City of Phoenix PLANNING AND DEVELOPMENT DEPARTMENT

Staff Report Z-18-21-8 May 6, 2021

Proposed Use: Assisted living facility

Location: Northwest corner of 10th Street and Baseline Road

Conceptual Site Plan, Source: Architectural Resource Team

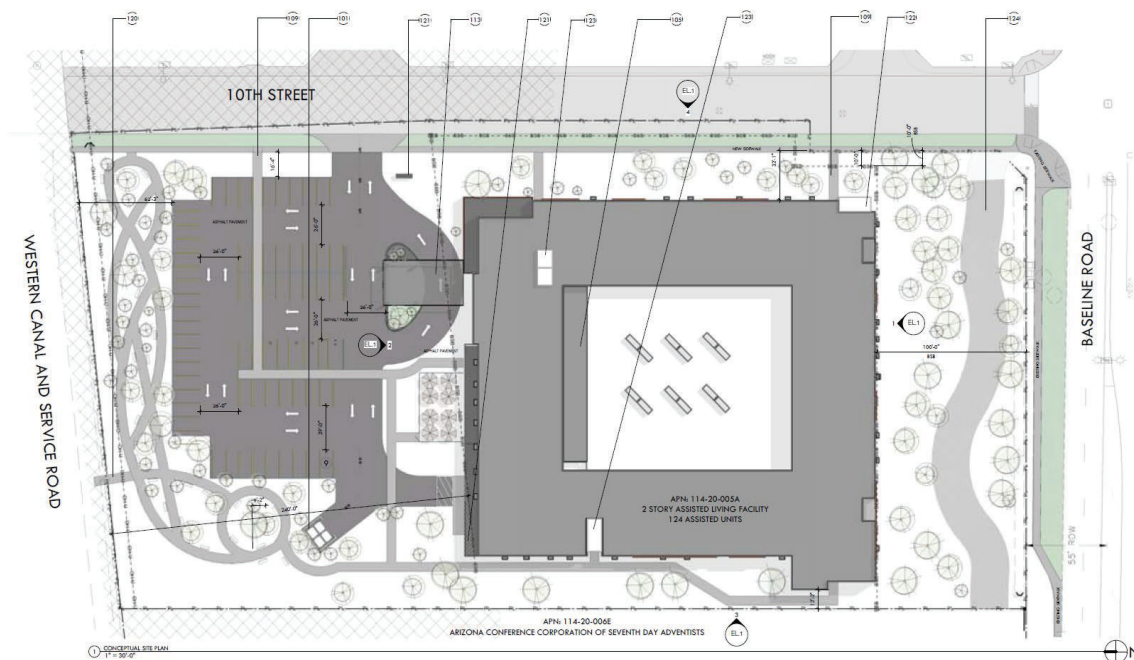
The applicant is proposing an assisted living facility (community residence center) with 124 beds in a single building located on the south portion of the property. The conceptual site plan shows a building designed around an open courtyard, that will provide residents with open space close to their living quarters. The proposed building will be two stories and 30 feet in height. A single vehicular access points to the subject site is proposed along 10th Street, connecting the parking area located on the north portion of the site, which is presently located in a floodplain. Multiple pedestrian connections are proposed to connect the site along 10th Street, plus connect the building to the amenity area along the north.

Staff is recommending Stipulation No. 7 to require a pedestrian circulation plan providing a minimum of two pedestrian connections to 10th Street; illuminated pedestrian-scale lighting along internal paths connecting the site north to south; decorative or alternative paving material for pedestrian paths to contrast parking or drive aisle surfaces; and connections to/between: all buildings, active open space areas, adjacent public sidewalks, the Western Canal, and the bus pad along Baseline Road.

Conformance to the conceptual site plan provided by the applicant is not recommended by staff since a significant portion of the site along the north is within a floodplain. This will allow additional flexibility to the applicant during the site plan review process shall issues arise with addressing floodplain requirements.

Staff recommends Stipulation No. 8 to require an enhanced entryway along the primary entrance to the development, presently shown as 10th Street which is designated as a minor collector street that connects a scenic road with the Western Canal. These enhancements include landscaped accent areas on both sides of the driveway that incorporate annuals and citrus trees in conformance with the Baseline Area Master Plan plant list, and alternative driveway surface materials to accentuate the entryway.

SCHEMATIC
BUILDING
ELEVATIONS
DRAWING NO.

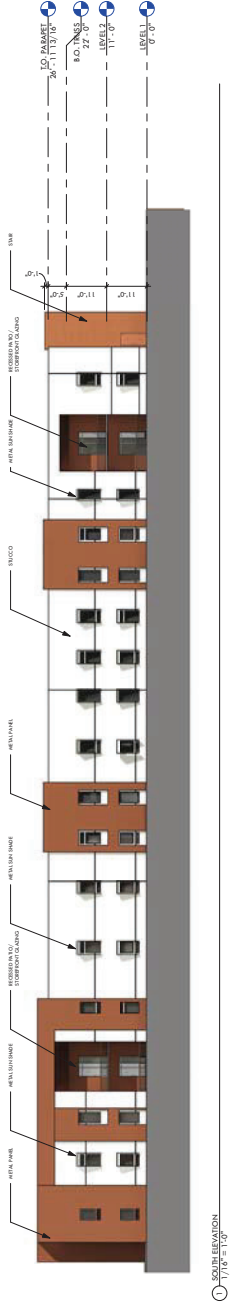
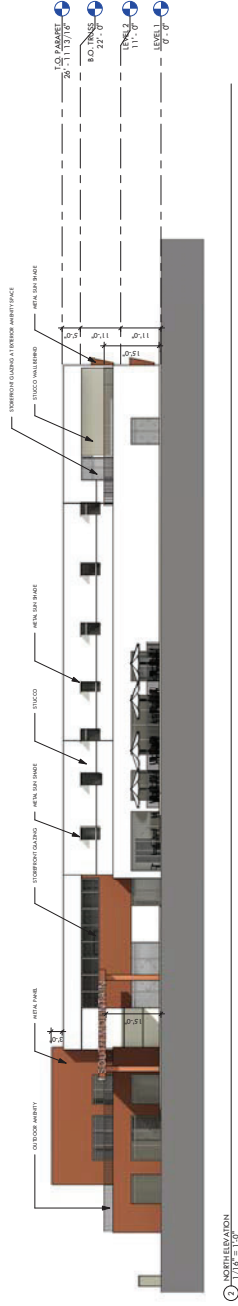
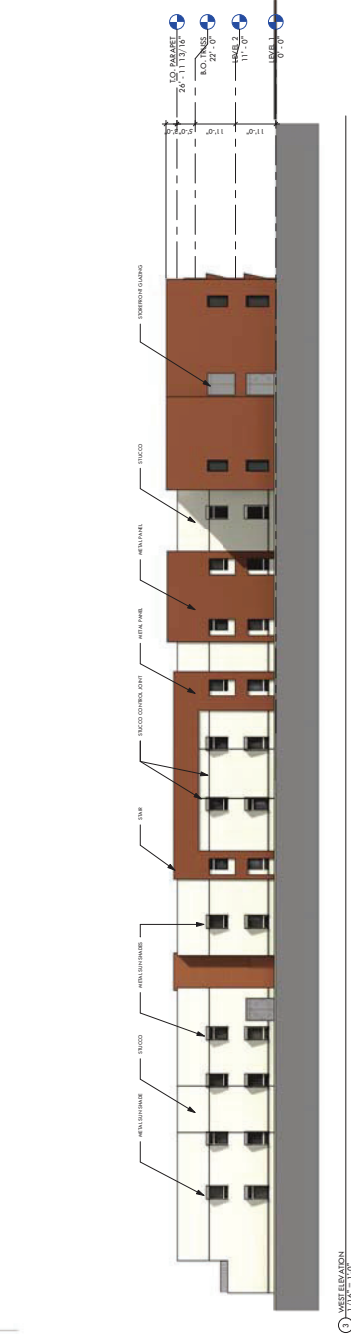
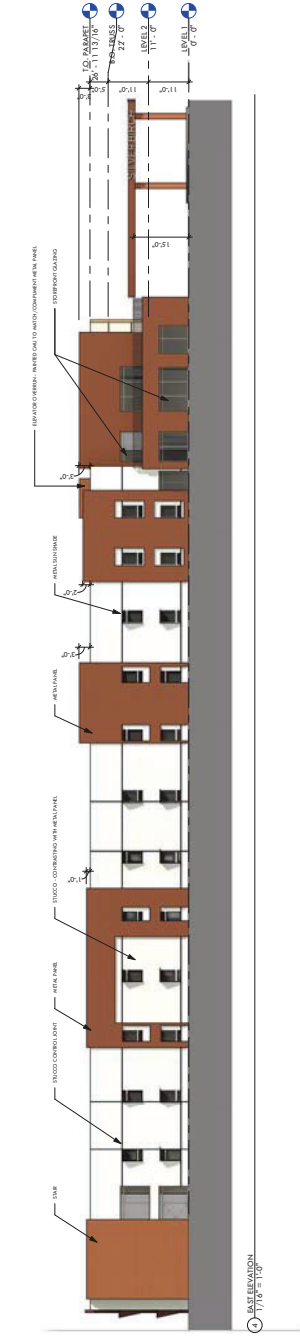
The conceptual building elevations depict a single building with architectural features such as a flat roof, recessed patios, sunshades, stucco plus metal exterior materials and four-sided architecture. The conceptual building elevations proposed depict a maximum height of two stories and 30 feet to the top of parapet.

Conformance to the conceptual building elevations is not currently proposed as a design presumption in the BAOD requires that pitched roofs be incorporated in all buildings. Furthermore, since conformance to the conceptual site plan is not recommended by staff to allow additional flexibility in addressing floodplain issues, if these arise during the site plan review process, these conceptual building elevations may change as well. Stipulation No. 1 and the design guidelines and standards per the BAOD will ensure the use of pleasing aesthetics and durable materials in addition to architectural features consistent with historical architecture in the area are incorporated into the building elevations.

Staff is recommending a stipulation to require building elevations to incorporate a variety of colors, materials and architectural features, as mentioned previously in this report, and is addressed in Stipulation No. 1. This stipulation also requires that a minimum of 25 percent of building elevations adjacent and oriented towards public streets provide accent materials that exhibit quality and durability in order to ensure that the buildings on this site remain visually appealing, and that all sides of the building/s include architectural establishments.
